**DOCUMENT NO:** OP-1903.010

**TITLE:** EMERGENCY ACTION LEVEL  
CLASSIFICATION

**REVISION NO:** 036-02-0

**CHANGE NO:** PC-02

**Attachment 8 (0CNA08005)**  
**Unit 2 Failed Fuel Radiation Plot**  
**mRem/hr at 2TCD-19**

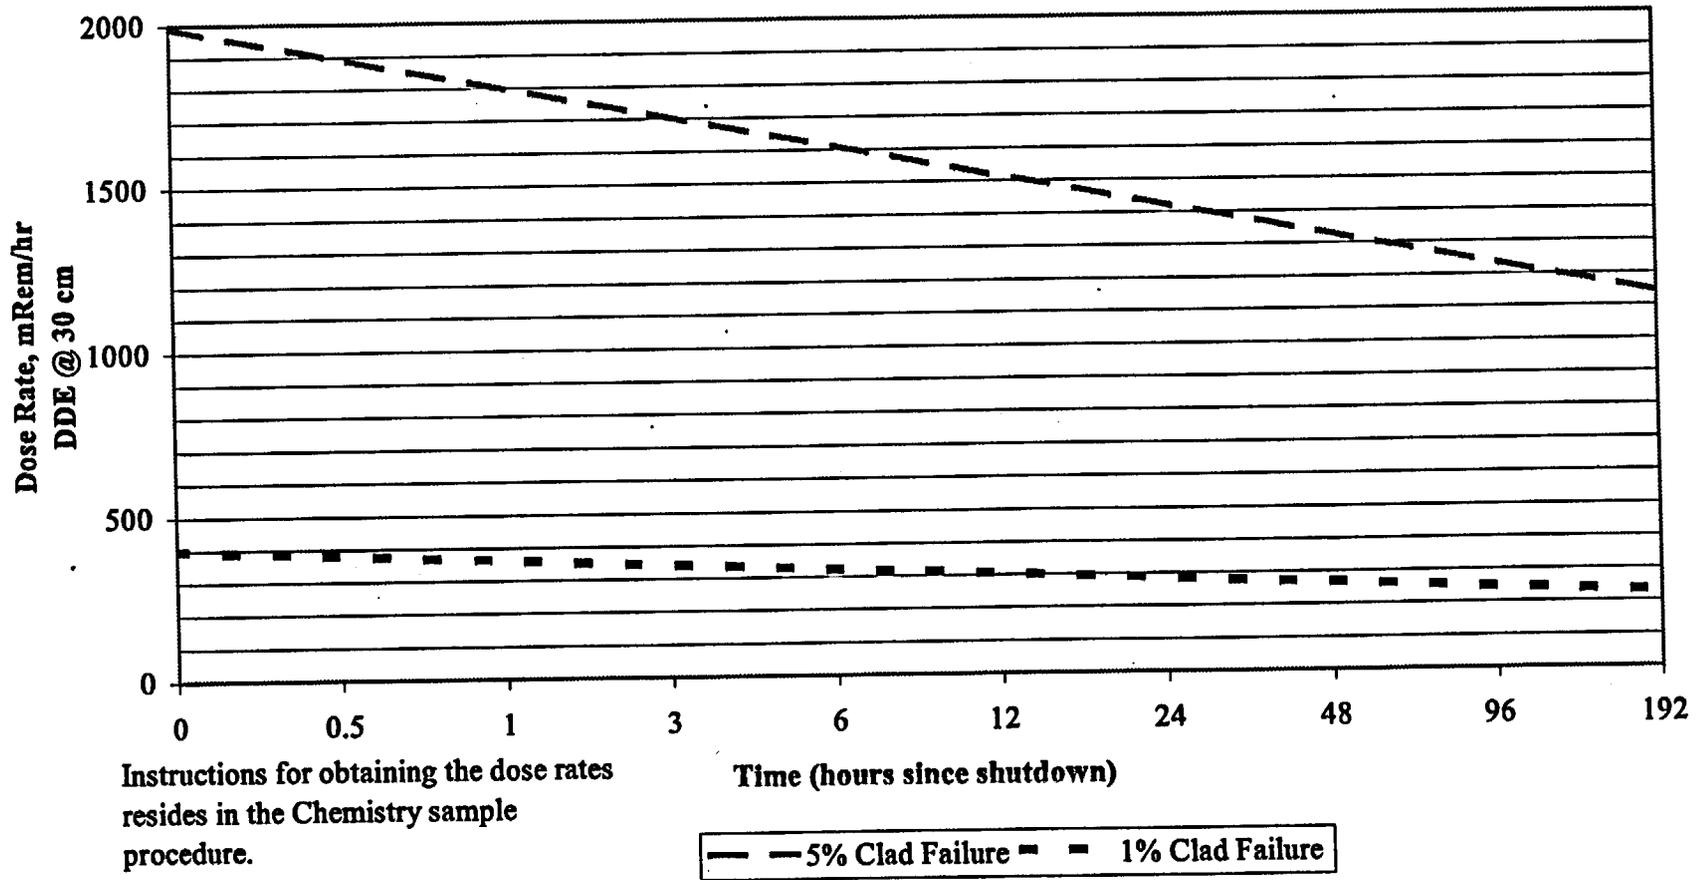
Unit 1 EAL 3.5 Criteria	Added a caution, "Caution As Primary-to-Secondary leakage approaches 50 gpm, consider transitioning to EAL 1.7"		
Unit 1 EAL 6.4 Criteria	Deleted Criteria 1, "The following conditions exist in the PASS building: A. SPING is inoperable AND B. PASS sampling is in progress AND C. Inability to obtain and analyze local grab samples every 2 hours <u>OR</u> Renumbered as appropriate		
Unit 2 EAL 1.2 Criteria	Added "either of the following" and " <u>OR</u> " and "2. Radiation levels that indicate >1% failed fuel per Unit 2 Failed Fuel Radiation Plot (Att 8)"

**Attachment 7 (0CNA08005)**  
**Unit 1 Failed Fuel Radiation Plot**  
**mRem/hr at SA-229**

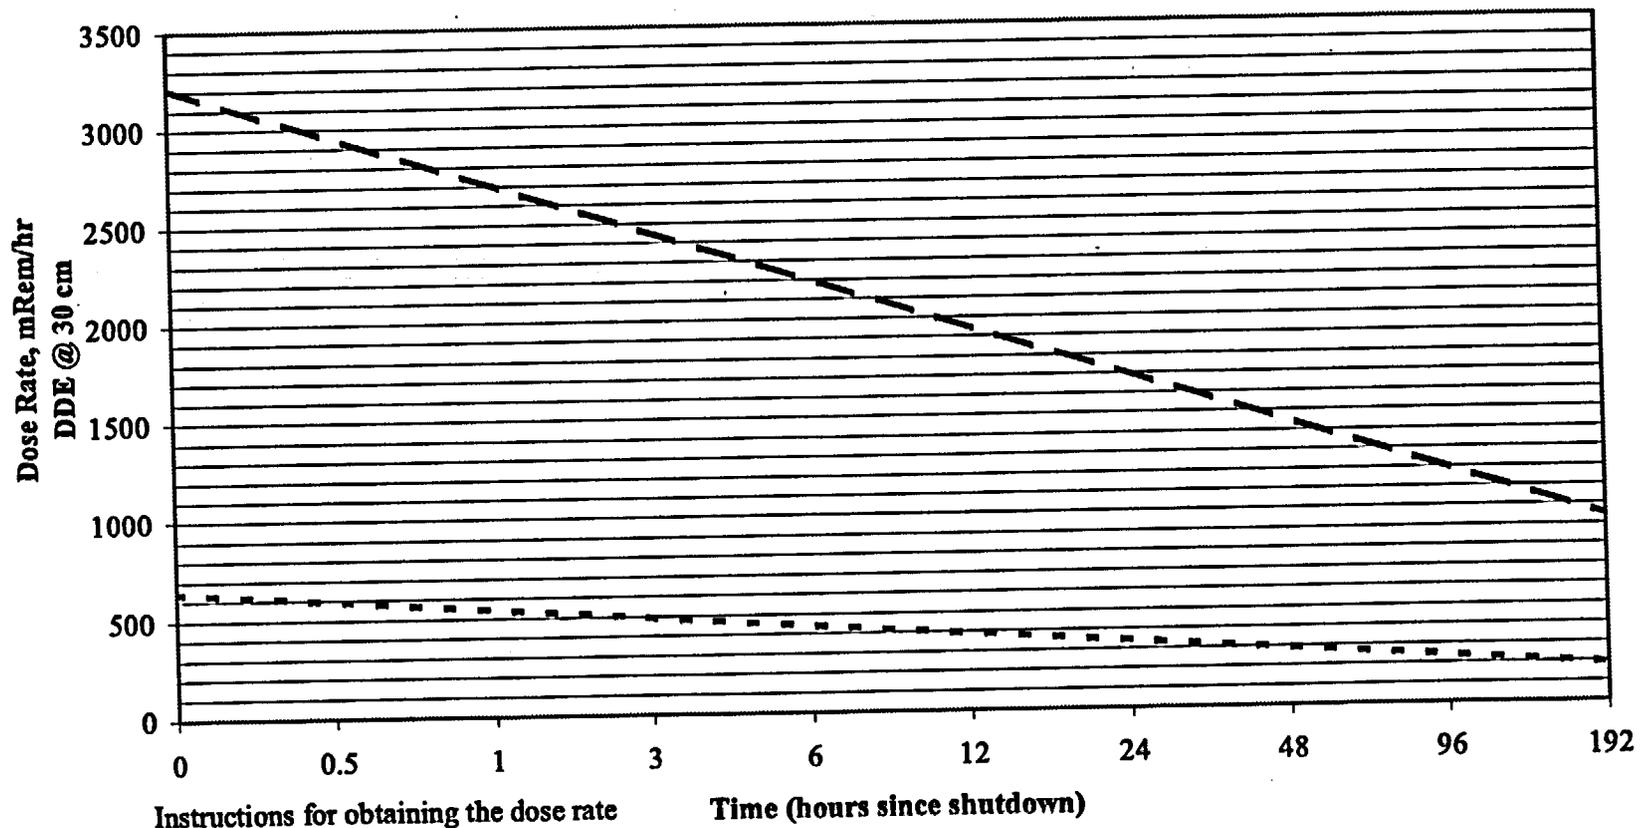
Step 3.2.15	Added reference to procedure 2607.001. This procedure contains the instructions for post accident sampling via the Unit 2 primary sample room.		
Step 4.16.1.A.2	Added "Radiation levels that indicate >1% failed fuel per Unit 1 Failed Fuel Radiation Plot (Att 7)". Renumbered following steps as appropriate.		
Step 4.16.1.B.2	Added "Radiation levels that indicate >1% failed fuel per Unit 2 Failed Fuel Radiation Plot (Att 8)". Renumbered following steps as appropriate.		
Step 7.7	Added "Attachment 7 - Unit 1 Failed Fuel Radiation Plot"		
Step 7.8	Added "Attachment 8 - Unit 2 Failed Fuel Radiation Plot"		
Unit 1 EAL 1.2 Criteria	Added " <u>OR</u> " and "2. Radiation levels that indicate >1% failed fuel per Unit 1 Failed Fuel Radiation Plot (Att 7)"		
Unit 1 EAL 1.3 Criteria	Added " <u>OR</u> " and "2. Radiation levels that indicate >1% failed fuel per Unit 1 Failed Fuel Radiation Plot (Att 7)"
